Customer : CU-DAR001 Dart Helicopters Services	Drawing Name : HELI UTILITY BASKET LH/RH 350/355
Job Number : 31799	
Estimate Number : 10208	
P.O. Number : <i>N/A</i>	Part Number : D350607043
This Issue : 4/12/2007 S.O. No. : <i>N/A</i>	Drawing Number : D350-607 REV F P7-9
Prsht Rev. : <i>NC</i>	Project Number : <i>N/A</i>
First Issue : <i>N/A</i> Type : LARGE FAB ASSY	Drawing Revision : F
Previous Run : 31772	Material : <i>N/A</i>
Written By : _____	Due Date : 5/18/2007 Qty: 1 Um: Each
Checked & Approved By : <i>[Signature]</i>	
Comment : Est Rev:E as Per DSI9318 06-01-24 JLM

DESIGN <i>CP</i>	DRAWN BY <i>CP</i>	DART AEROSPACE LTD HAWKESBURY, ONTARIO, CANADA	
CHECKED <i>[Signature]</i>	APPROVED <i>[Signature]</i>	DRAWING NO. DSI 9318	REV. A. SHEET 1 OF 1
DATE 06.01.06		TITLE WASHER ADDITION	SCALE NTS
A	06.01.06	NEW ISSUE

DART SERVICE INSTRUCTION

TO AMEND INSTALLATION INSTRUCTIONS D350-607 REV. F

Figure 5- Basket Replacement Parts
(D350-607-043 Heli-Utility-Basket™)

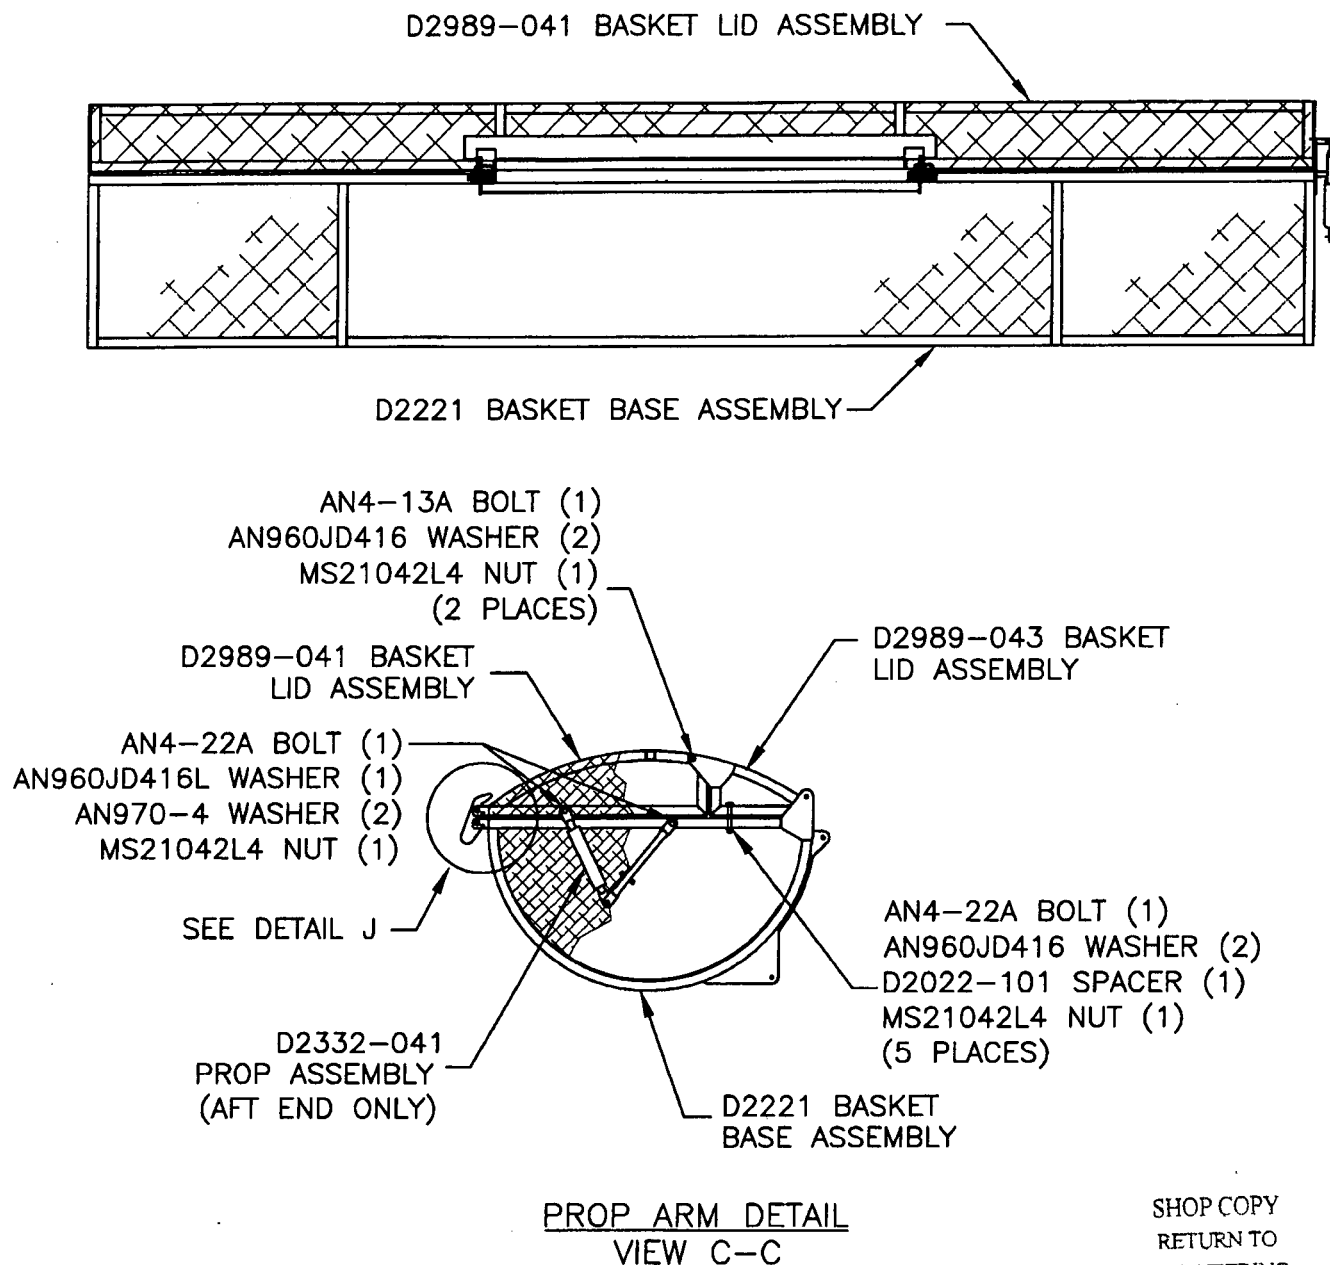
To reduce the possibility of damaging the finish, a **NAS1515H4** washer (2 places) has been added between the hinge plate and basket frame on the **D350-607-043/-047 Heli-Utility-Basket**.

The corrected bolt stackup from Figure 5 of installation instructions D350-607 Rev. F is given below:

AN4-13A BOLT (1)
AN960JD416 WASHER (1)
HINGE PLATE (REF)
NAS1515H4 WASHER (1)
BASKET FRAME (REF)
AN960JD416 WASHER (1)
MS21042L4 NUT (1)
(2 PLACES)
